DATE: April 13, 2022

TO: Chairman Robert Patrick, DeKalb County
ATTN TO: Larry Washington, Planning Administrator, DeKalb County
FROM: Mike Alexander, Director, ARC Center for Livable Communities
RE: Development of Regional Impact (DRI) Review

Name of Proposal: North Dekalb Mall Redevelopment DRI 3582

ZONING SITE PLAN
SHEET NUMBER
C1-50

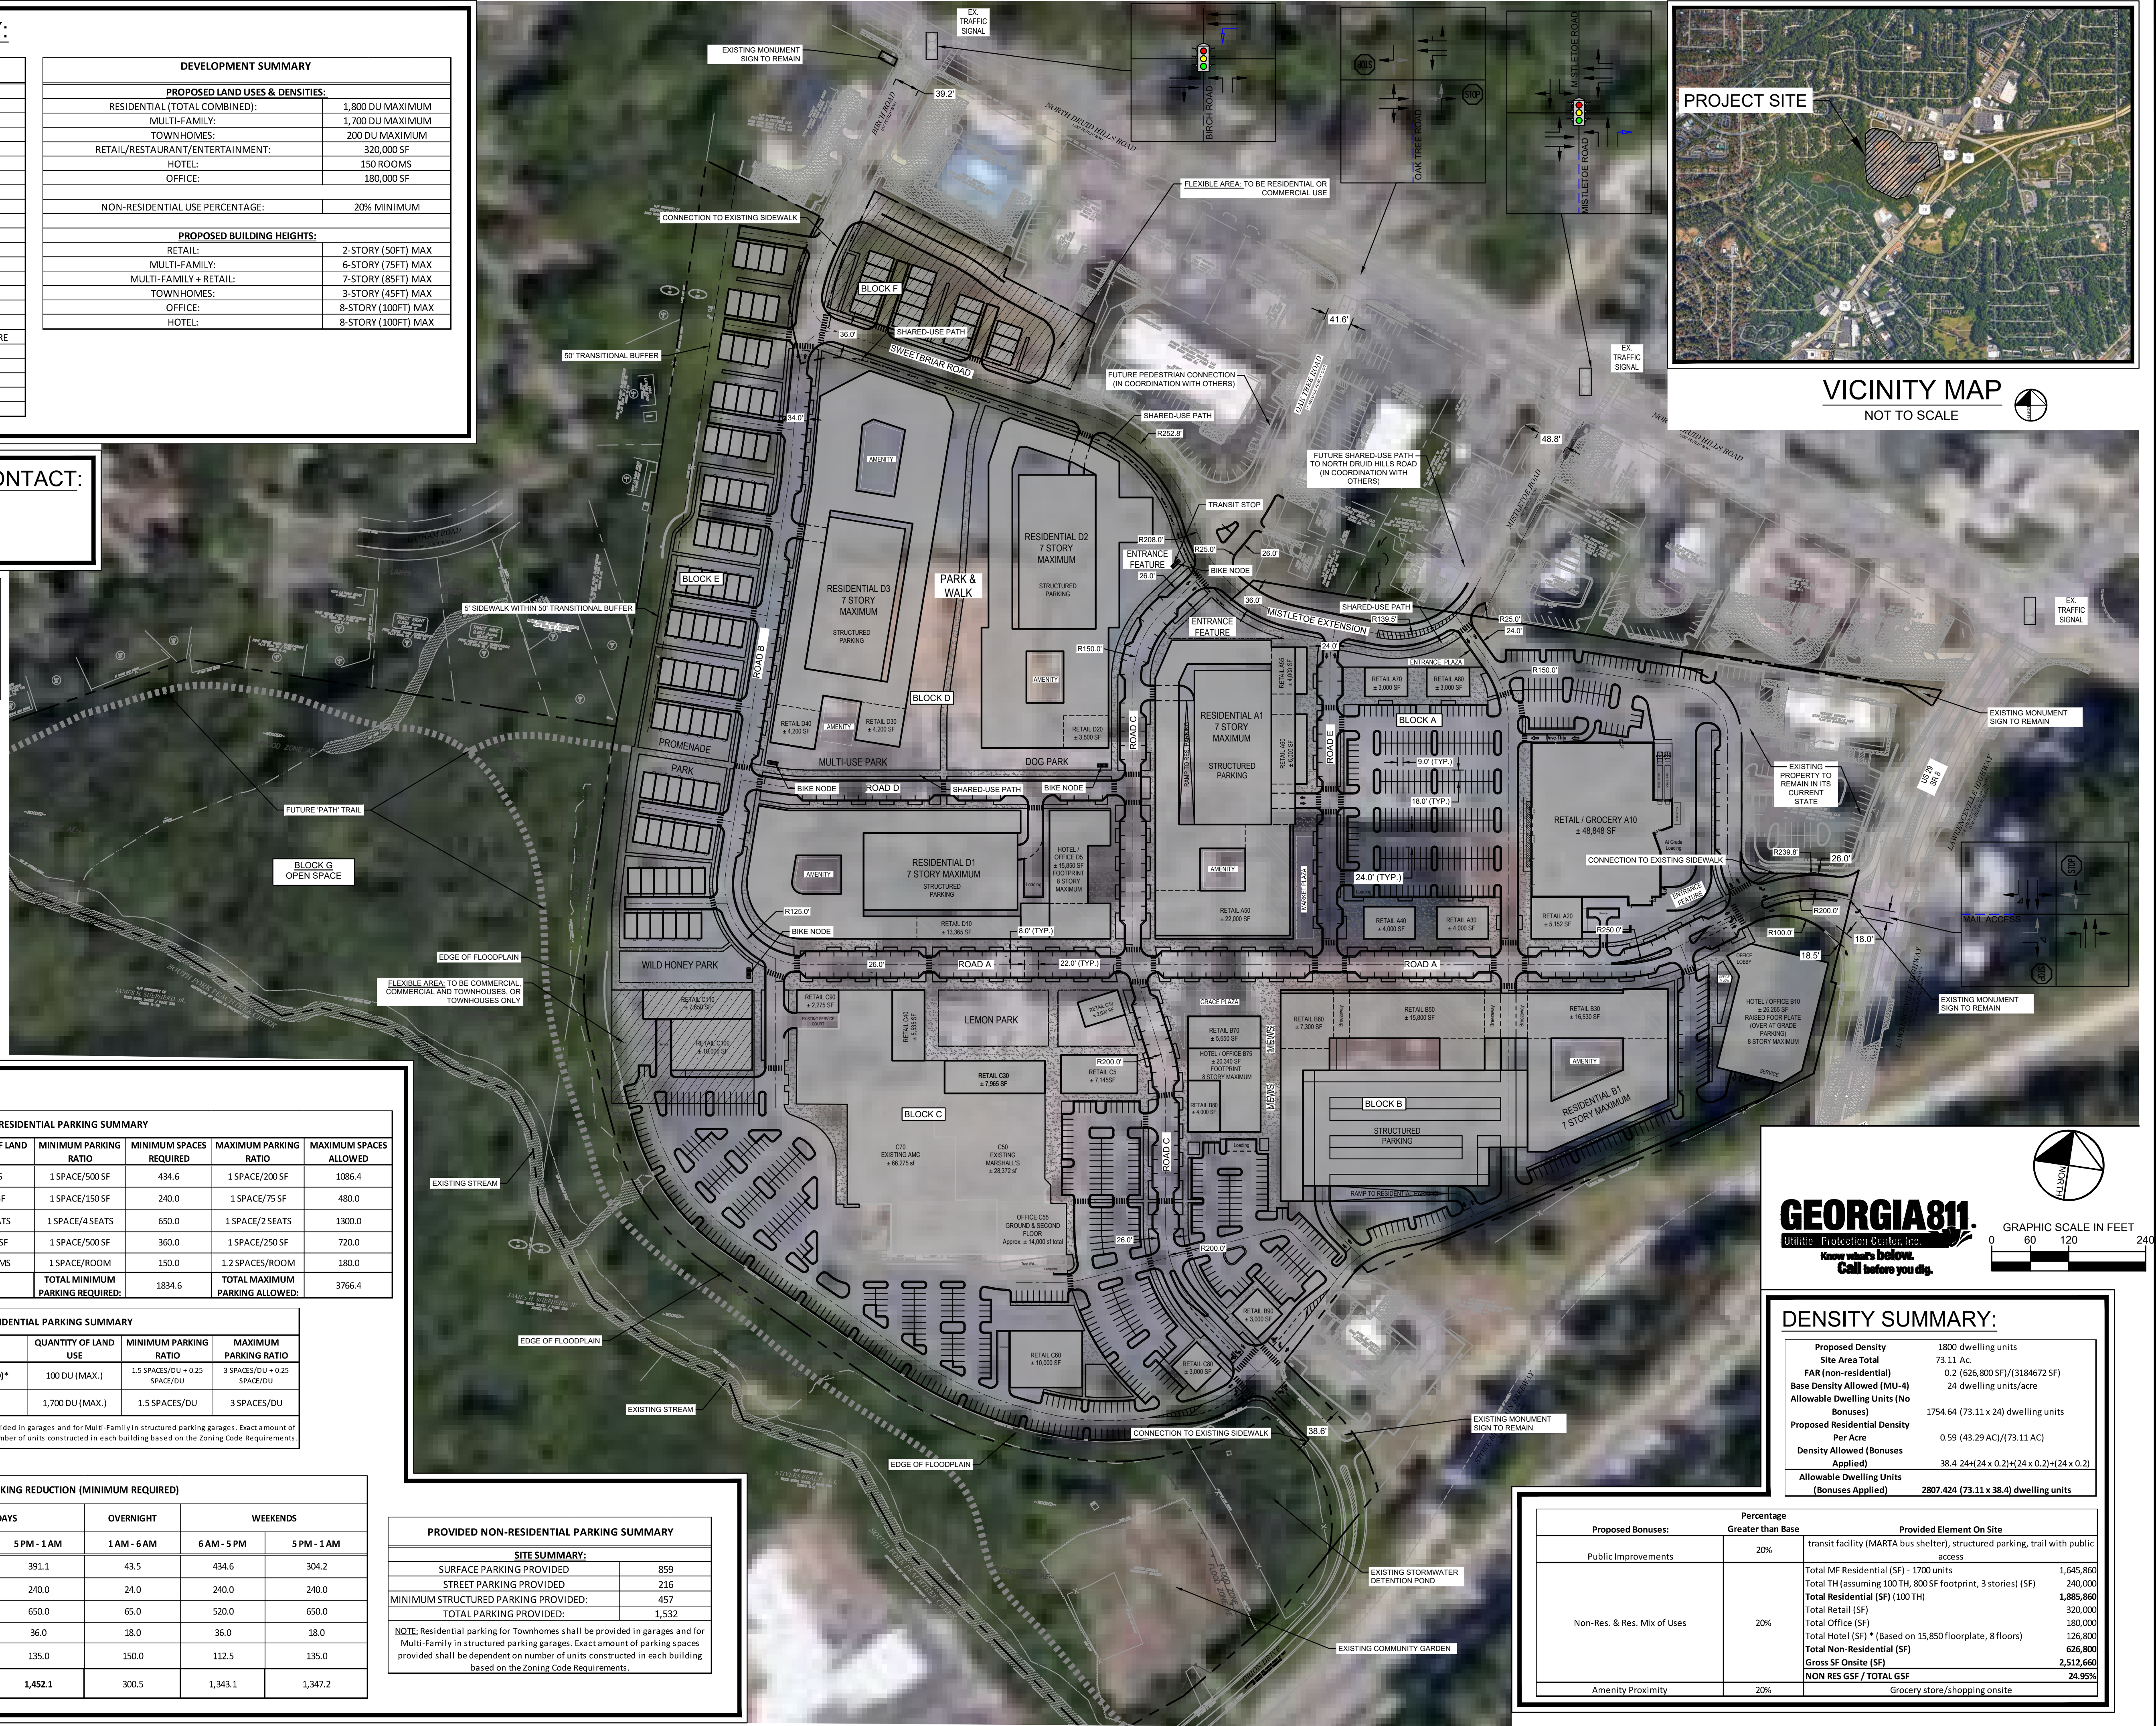
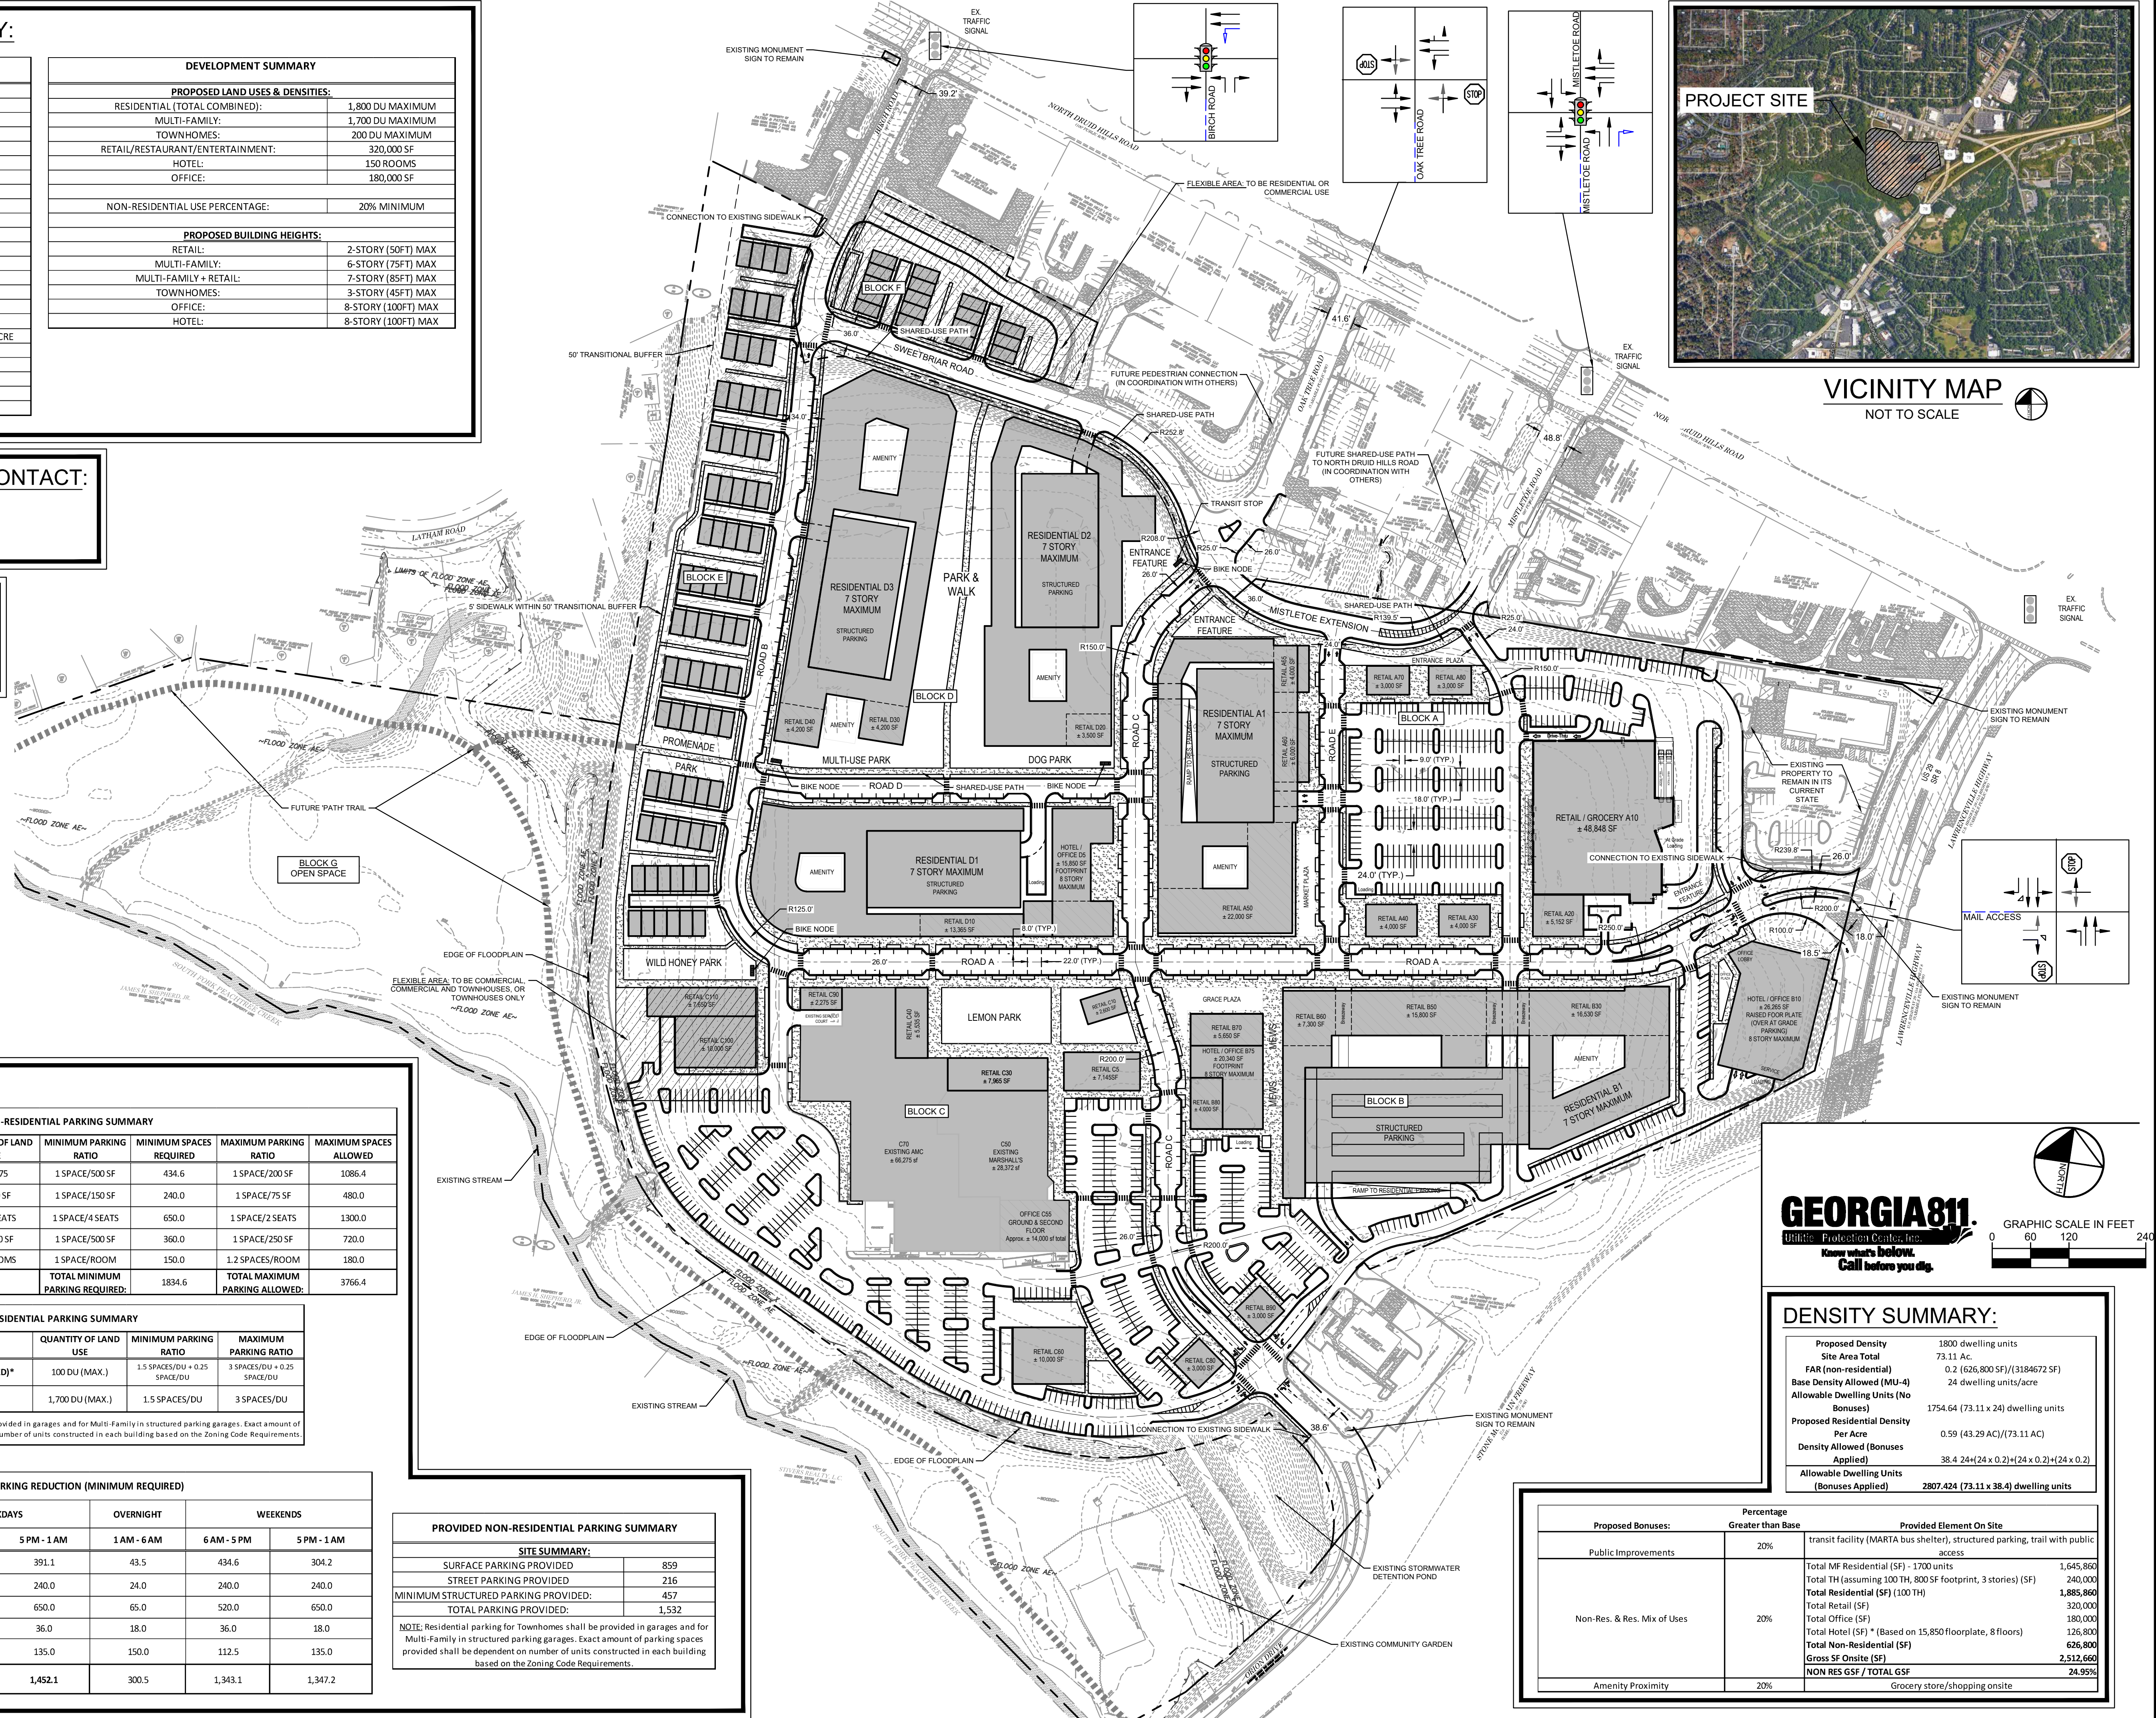
The site plan and the USGS coverage for the project area show the South Fork of Peachtree Creek forming the southwestern and western boundaries of the project property. The site plan also shows an unnamed tributary to the South Fork of Peachtree in the western end of the property. Neither the County 75-foot stream buffer or 25-foot State Sediment and Erosion Control buffer are shown along the streams. However, both are entirely within the conservation area portion of the project, which extends beyond the width of the buffers. The only proposed activity shown in the conservation area is a proposed future trail paralleling the South Fork of Peachtree Creek. Given that paths are allowed in the buffer under the DeKalb ordinance, a variance may not be needed outside the 25-foot State buffer. Any unmapped streams on the property may also be subject to the City buffer ordinance. Any unmapped State waters identified on the property may also be subject to the State 25-foot Sediment and Erosion Control buffer.

The site plan and the USGS coverage for the project area show the South Fork of Peachtree Creek forming the southwestern and western boundaries of the project property. The site plan also shows an unnamed tributary to the South Fork of Peachtree in the western end of the property. Neither the County 75-foot stream buffer or 25-foot State Sediment and Erosion Control buffer are shown along the streams. However, both are entirely within the conservation area portion of the project, which extends beyond the width of the buffers. The only proposed activity shown in the conservation area is a proposed future trail paralleling the South Fork of Peachtree Creek. Given that paths are allowed in the buffer under the DeKalb ordinance, a variance may not be needed outside the 25-foot State buffer. Any unmapped streams on the property may also be subject to the City buffer ordinance. Any unmapped State waters identified on the property may also be subject to the State 25-foot Sediment and Erosion Control buffer.
